Air Quality Impact Modeling Protocol – Operations and Maintenance Emissions

Outer Continental Shelf Permit

Revolution Wind Farm

APPENDIX C : EPA PROTOCOL COMMENTS AND REVOLUTION WIND RESPONSE TO COMMENTS

Figure A-7. Overland 1-hour Average Screening Results

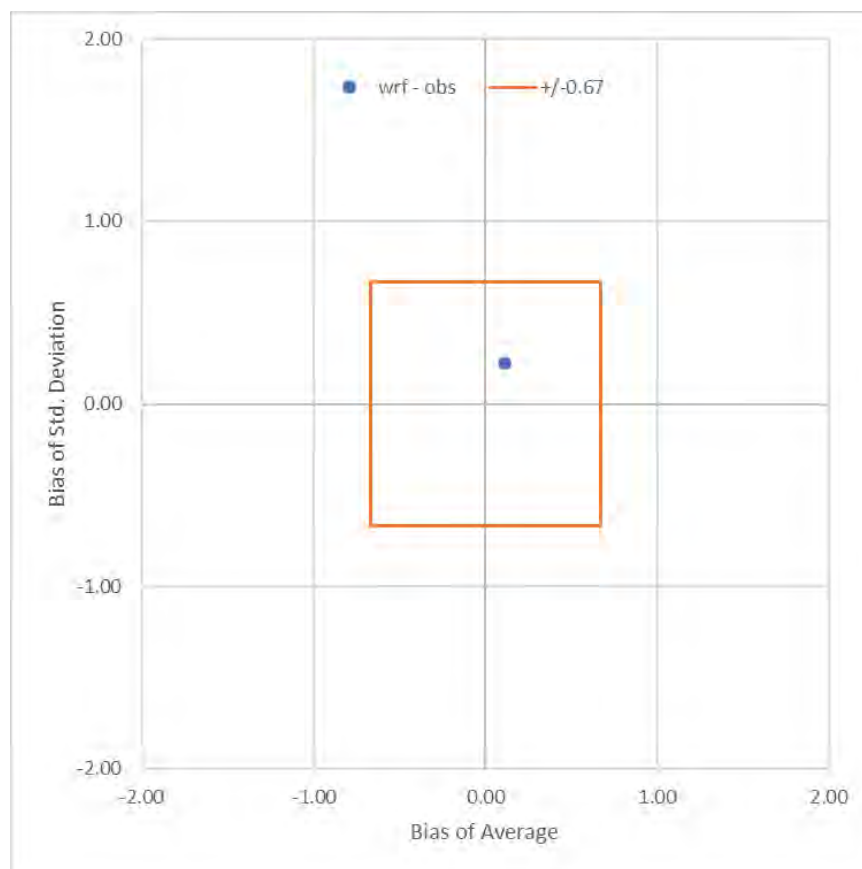
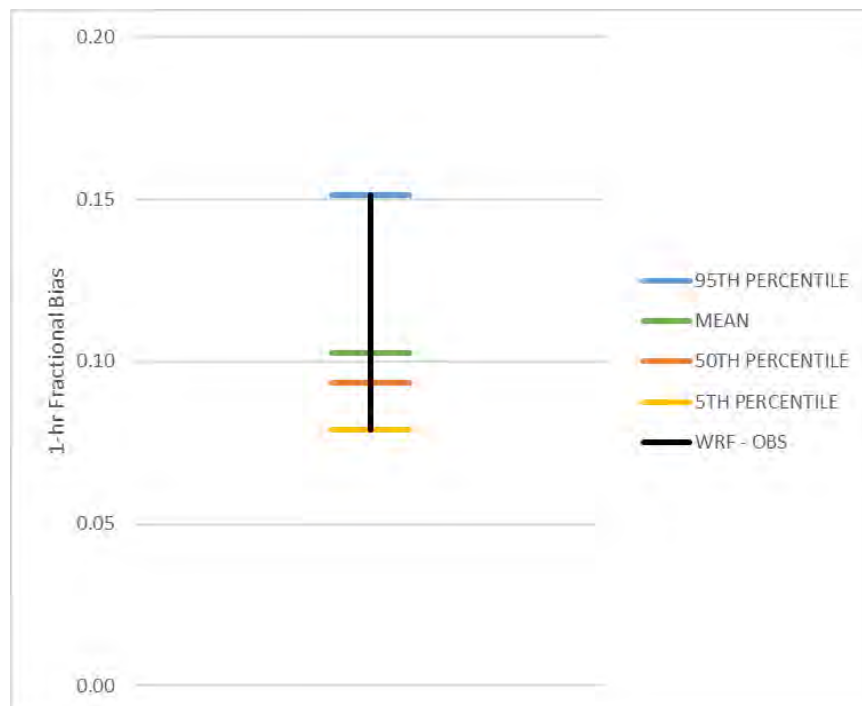
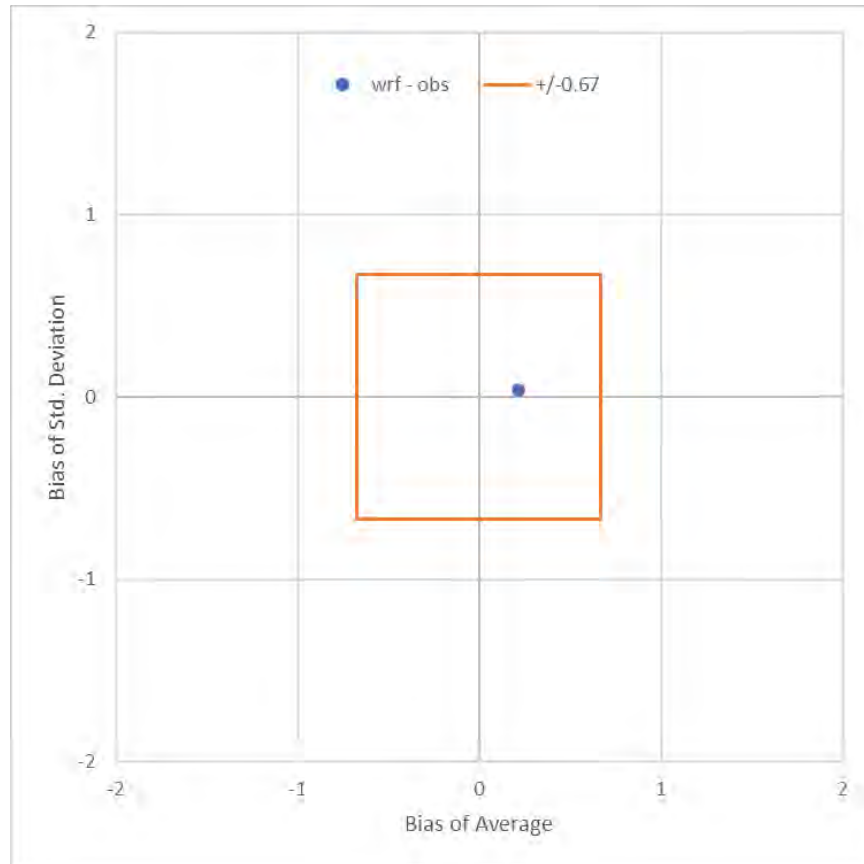
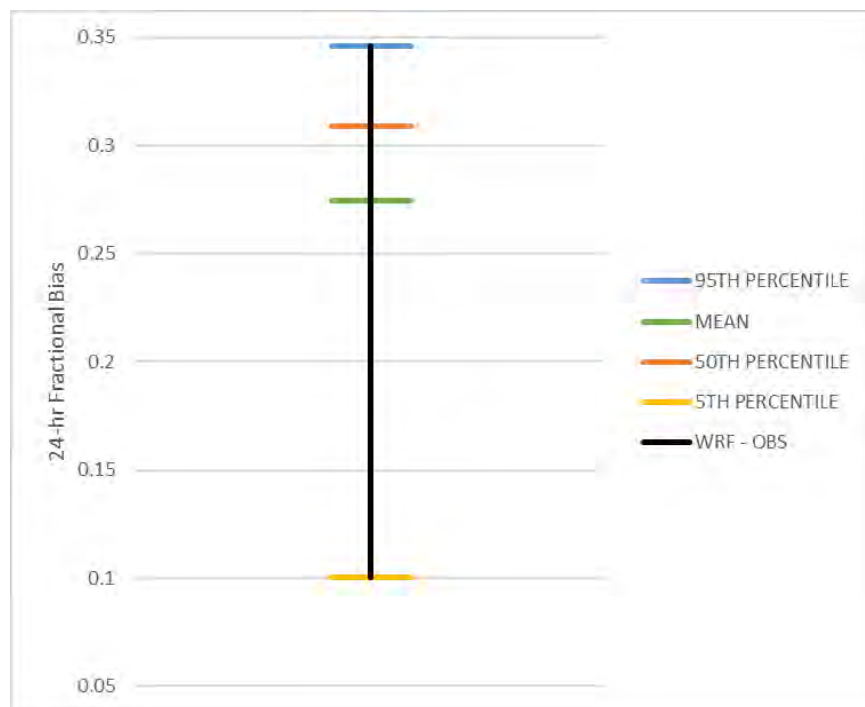
8. Explanation is requested regarding the statistical relationship between Figure A-7 and Figure A-9 and Figure A-8 and A-10.

8. *Section A.3.1. Explanation is requested regarding the statistical relationship between Figure A-7 and Figure A-9 and Figure A-8 and A-10.*

Figure A-13. Overwater 1-hour Average Screening Results

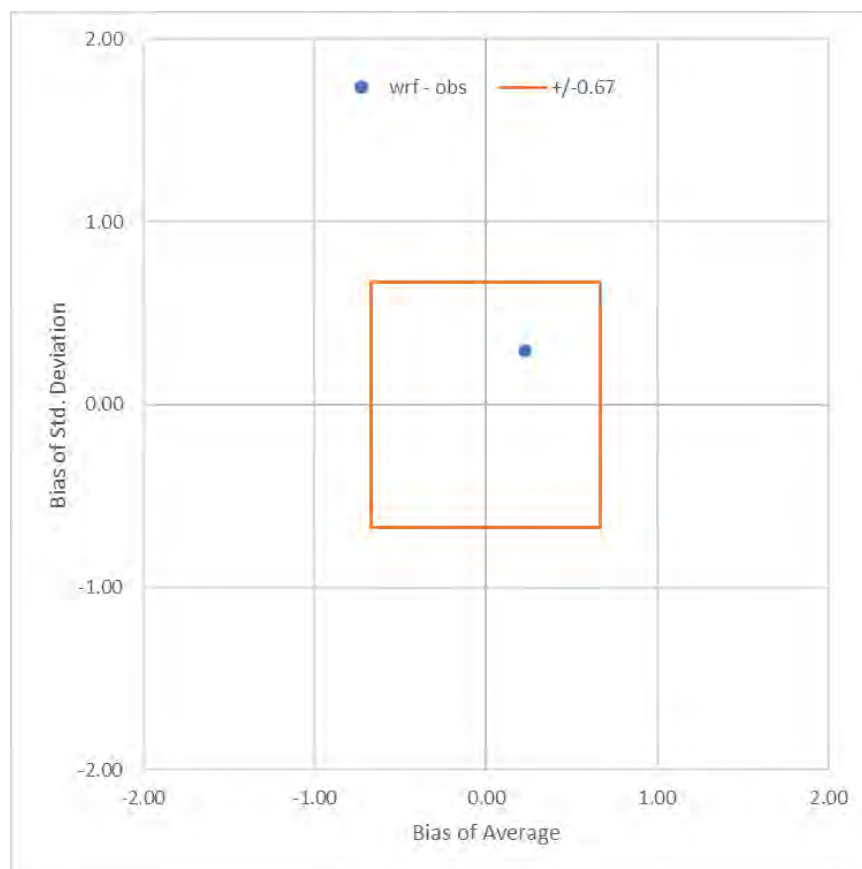
9. Figure A-13 depicts positive values of bias of the average greater than 2 for modeling for the 1-hour averaging period. Further discussion in the comparison of this issue is requested.
10. Explanation is requested regarding the statistical relationship between Figure A-13 and Figure A-15 and Figure A-14 and A-16.

9. *Section A.3.2. Figure A-13 depicts positive values of bias of the average greater than 2 for modeling for the 1-hour averaging period. Further discussion in the comparison of this issue is requested.*

An error was identified causing the bias to appear larger than it is. The error has been corrected in Figure A-13.

Figure A-14. Overwater 24-hour Average Screening Results

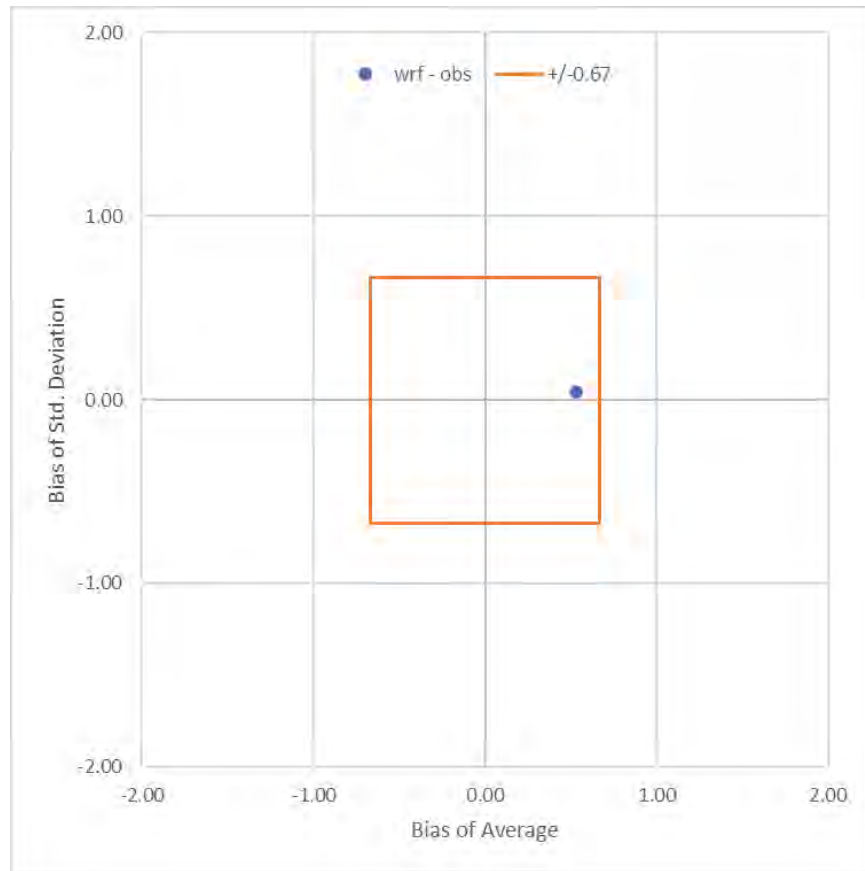
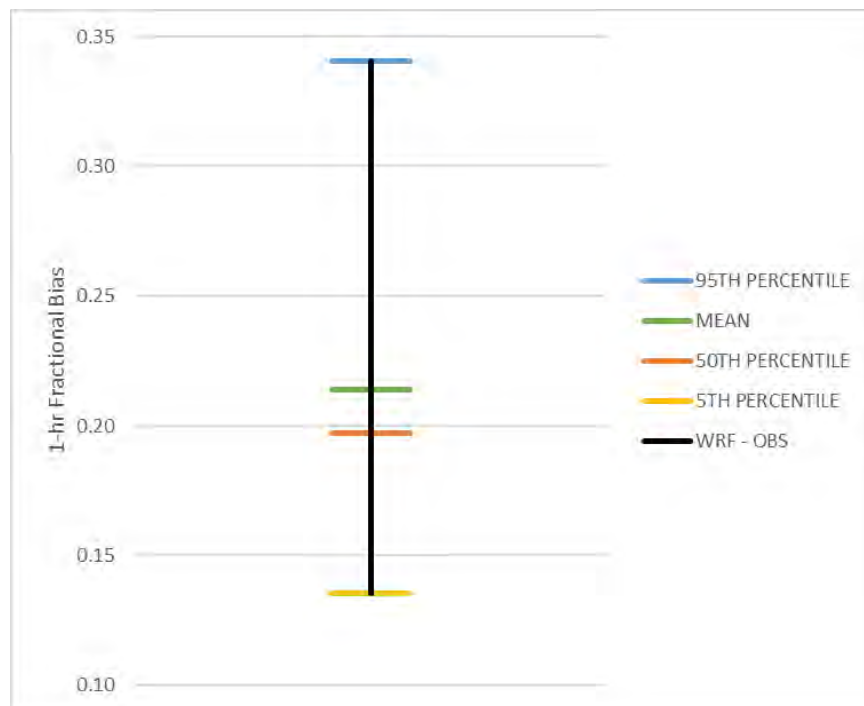
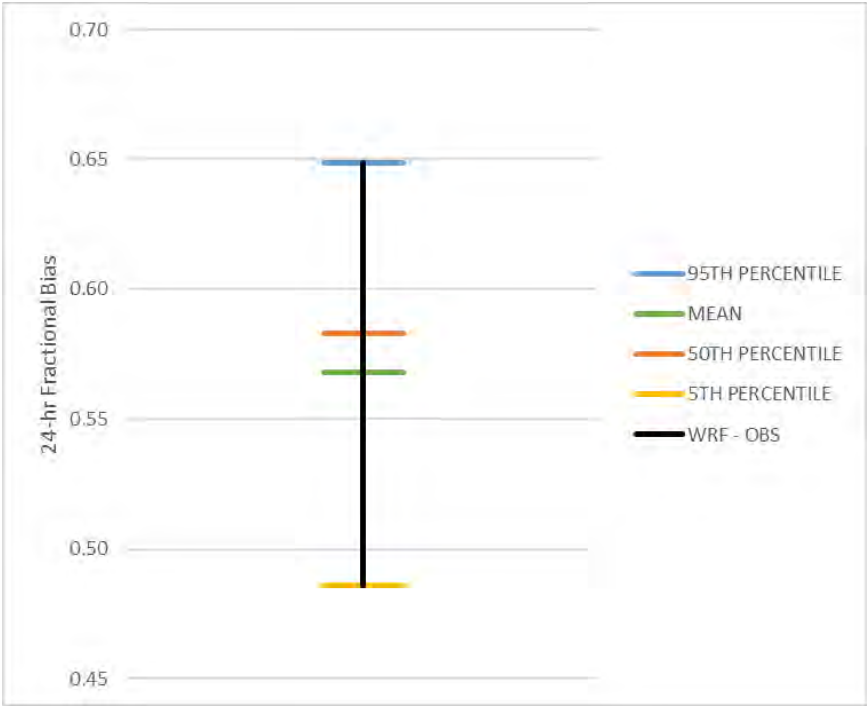
10. *Section A.3.2. Explanation is requested regarding the statistical relationship between Figure A-13 and Figure A-15 and Figure A-14 and A-16.*
